## **Planning and Zoning Commission - Special Meeting AGENDA**

STAFF REPORT  
KETCHUM PLANNING AND ZONING COMMISSION  
SPECIAL MEETING OF FEBRUARY 23<sup>rd</sup>, 2021

- PROJECT:** Warm Springs Ranch
- FILE NUMBERS:** P 21-001, P21-002, P21-003, and P21-010
- APPLICATION TYPES:** Development and Rezoning Agreement, Large Block Preliminary Plat, Block 1 Subdivision Preliminary Plat, and Floodplain Development/Waterways Design Review

**C-3**

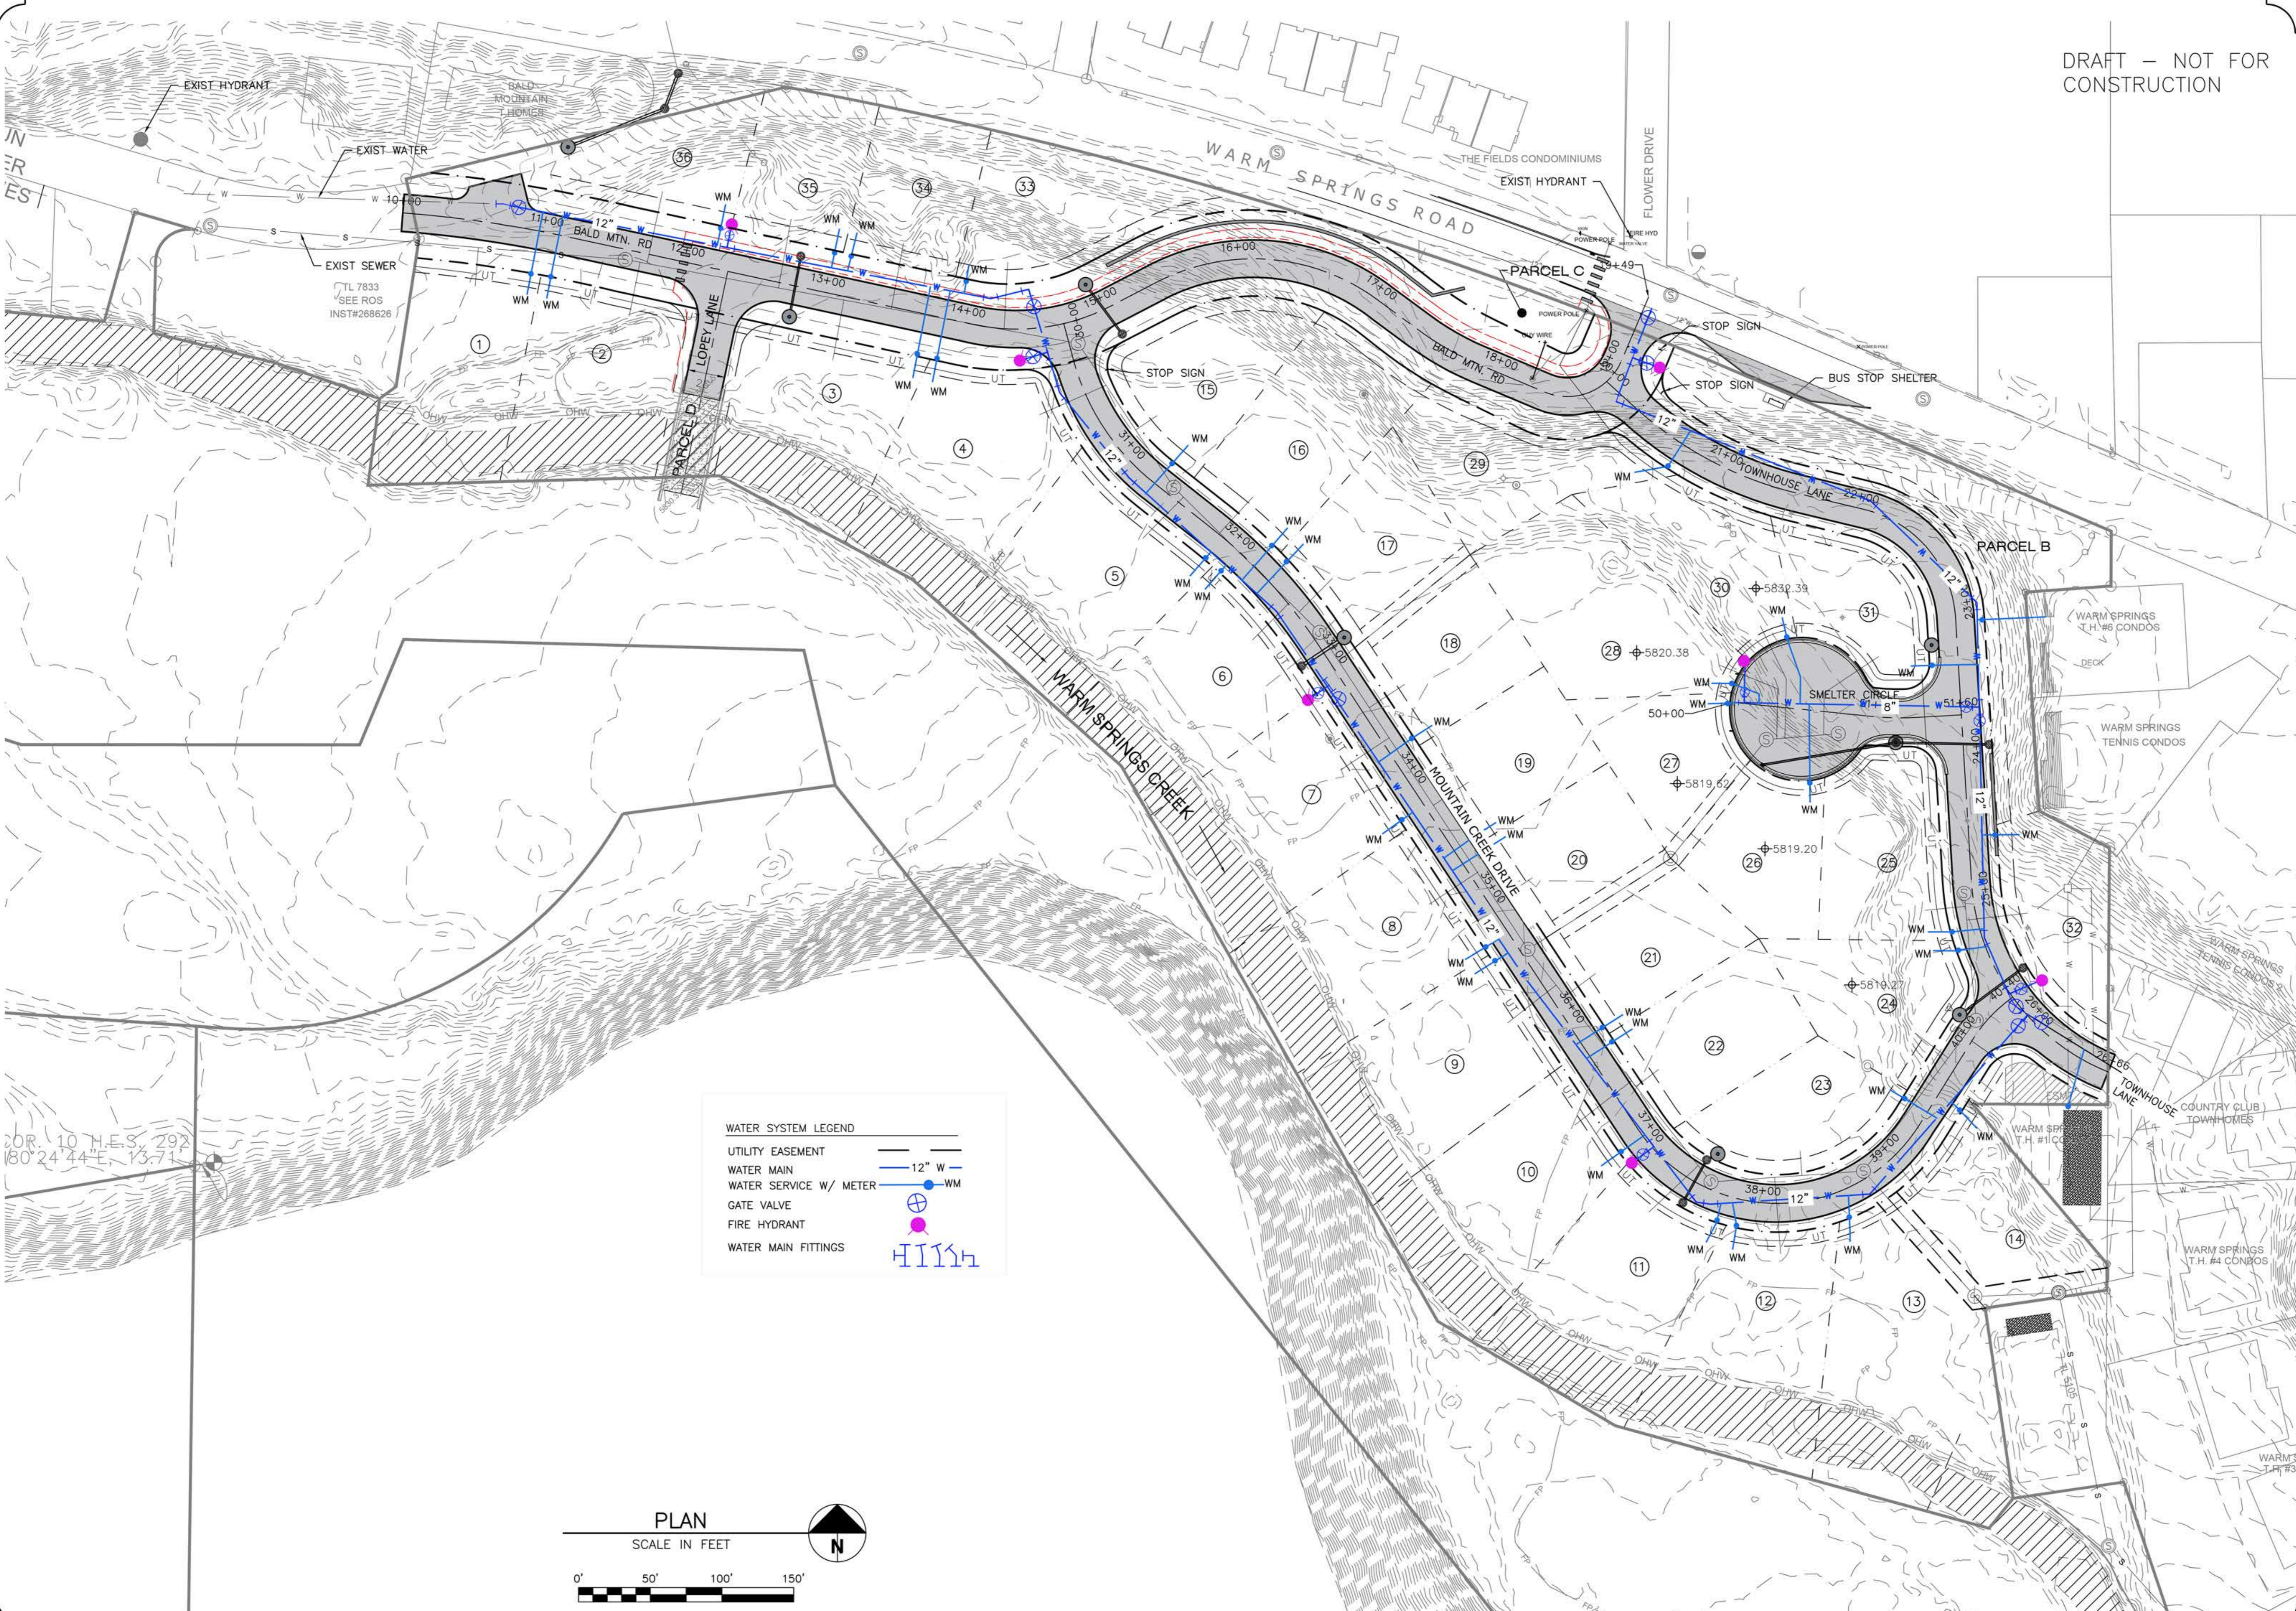
<b>Staff Comments</b>	<i>The new bus shelter is indicated on Parcel B (Sheet C-3). Mountain Rides has reviewed and approved the preliminary plans for the proposed bus stop location.</i>
<input checked="" type="checkbox"/>	<input type="checkbox"/>	<input type="checkbox"/>	<b>16.04.040.R</b>	<b>R. Avalanche And Mountain Overlay: All improvements and plats (land, planned unit development, townhouse, condominium) created pursuant to this chapter shall comply with City of Ketchum Avalanche Zone District and Mountain Overlay Zoning District requirements as set forth in Title 17 of this Code.</b>
			<b>Staff Comments</b>	<i>The Block 1 Subdivision Preliminary Plat will create 36 single-family residential lots and parcels A, B, C, D, and E. The proposed Development Agreement will rezone Block 1 from Tourist (T) to General Residential (GR-L) Low Density. Portions of Block 1 are also within the Floodplain Overlay and Avalanche Zone.</i>
